Access Compliance Report

Public Rights-of-Way

| Intersection ID: 48767 | Main Street: TURNING_WHEEL_DR | Cross Street: MINITREE_LN | Location: SW |
| ADA ID: 33AAF4D76B86 | Ramp Type: PerpDiag | Initial Pass/Fail: Fail | Overall Compliance: No |

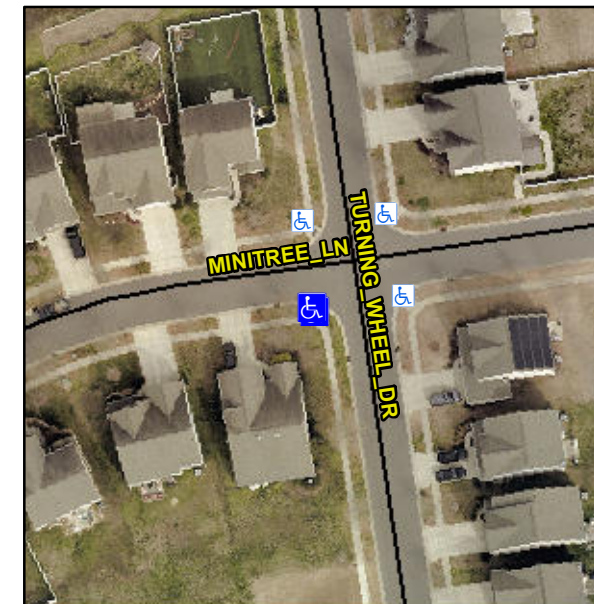
| Severity Score: 8.75 | | | |

R304.5.1

| Compliance | Description | Data | Compliance | Description | Data |
|------------|-----------------------|------|------------|-----------------------------|------|
| No | Ramp Width (in) | 47.0 | Yes | Ramp XSlope (%) | 1.5 |

Remove & Replace Curb Ramp With Two New Directional Ramps or Equivalent.
